ERRATUM:
TCR Turbocharger Boost Pressure Monitoring Method

This document corrects tipping errors in the Monitoring Method published in the TCR Technical Bulletin no. 4/2019. Changes are highlighted.

2.2. Block Diagram

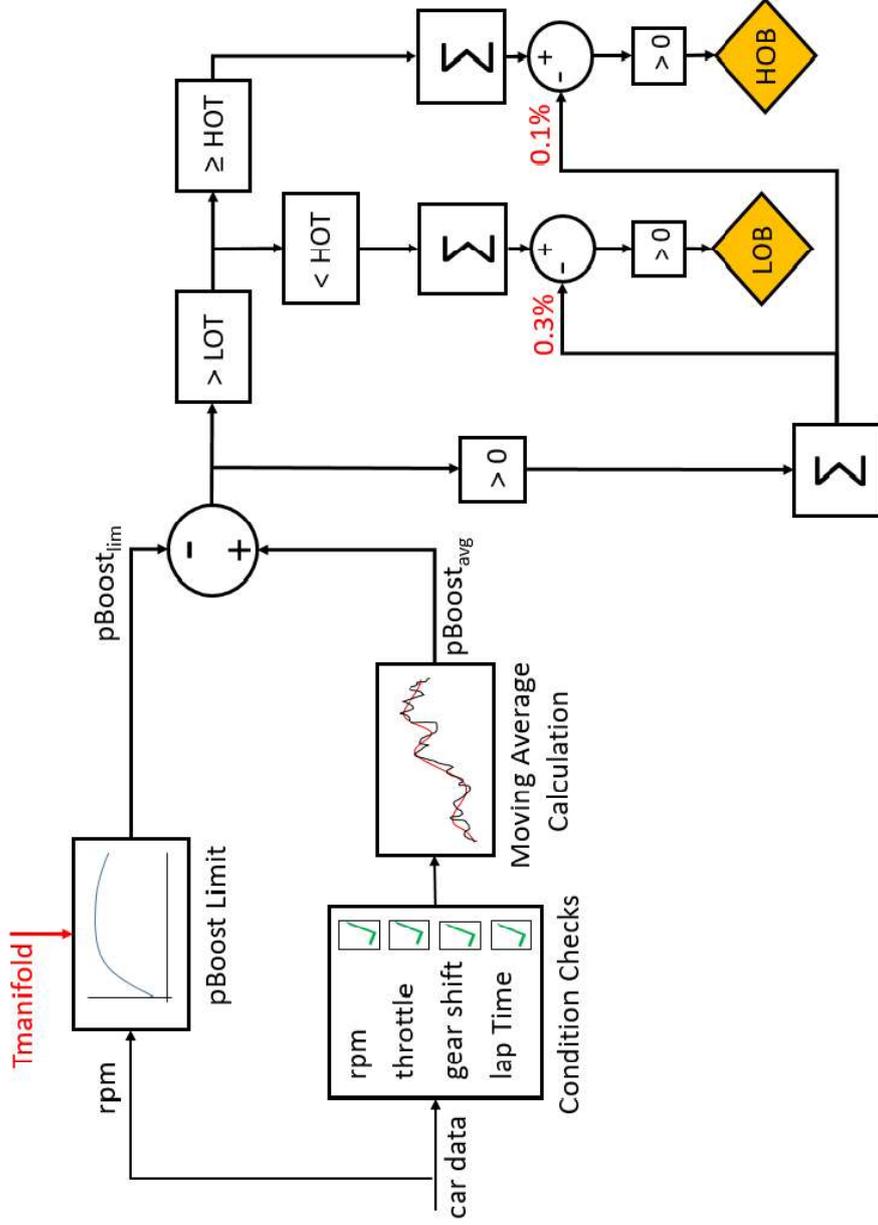
The diagram on next page shows the entire boost pressure monitoring method including all conditions for verification (corrected values according to the description).
